WILLIAMSON COUNTY, TEXAS

CHANGE ORDER NUMBER: 1

CR 138 Right Turn Lane at SH 130 Williamson County Project No. 24IFB19

Change Order No. 1

PROPOSED S4

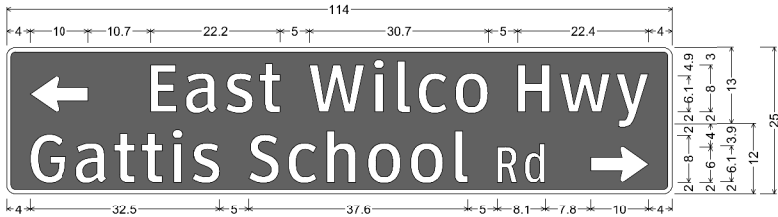
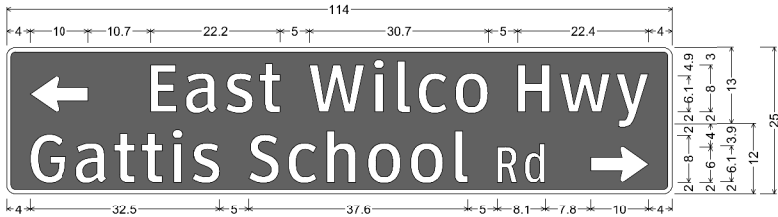
REMOVE AND REPLACE EXISTING SIGN

- TXDOT TO VERIFY ADEQUACY OF EXISTING MAST ARMS TO SUPPORT PROPOSED SIGNS S4 AND S6.
- ALL SIGN DIMENSIONS SHOWN ARE IN INCHES.

PROPOSED S5

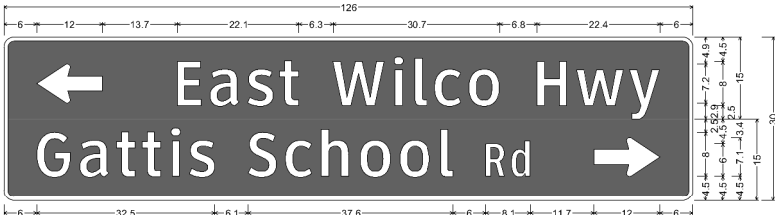
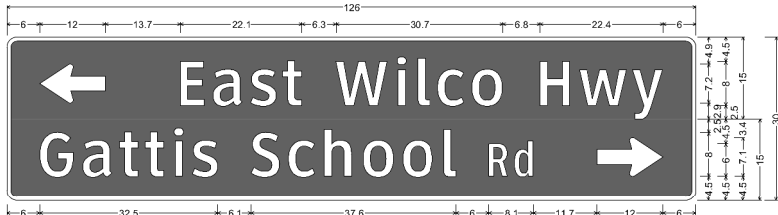
REMOVE AND REPLACE EXISTING
SIGN. NEW SIGN LOCATION - SEE
SUMMARY OF SMALL SIGNS.

PROPOSED S6

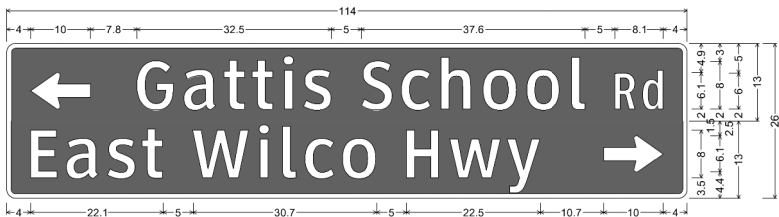
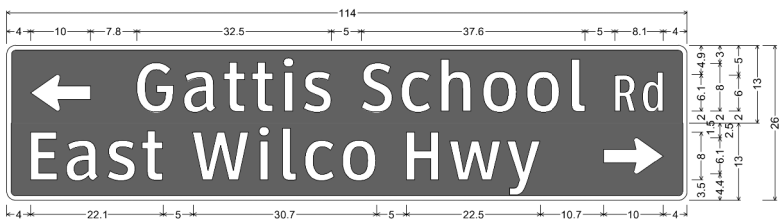
REMOVE AND REPLACE EXISTING SIGN

PROPOSED S7

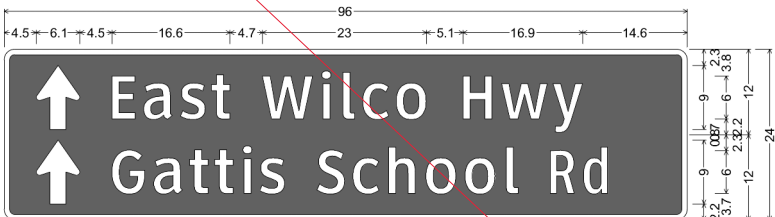
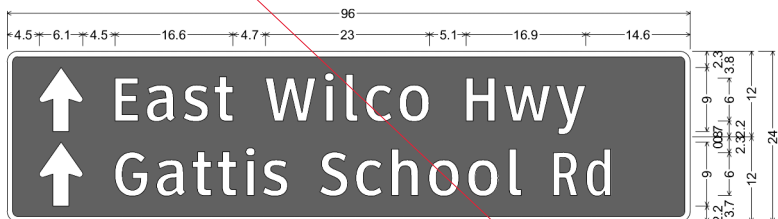
REMOVE AND REPLACE EXISTING
SIGN. NEW SIGN LOCATION - SEE
SUMMARY OF SMALL SIGNS.

PROPOSED S11

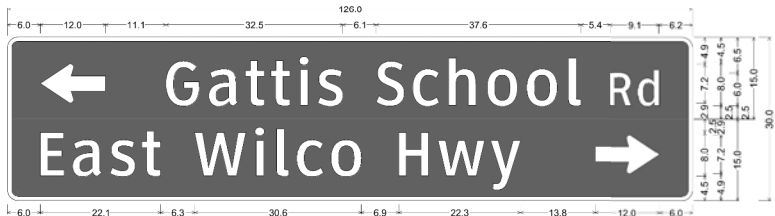
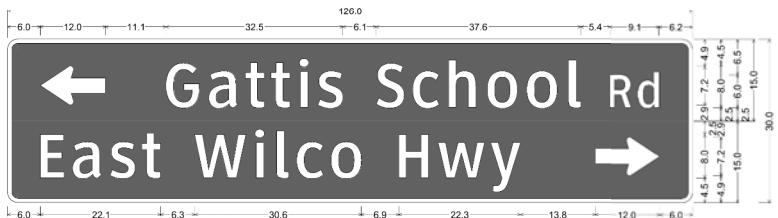
REMOVE AND REPLACE EXISTING
SIGN.
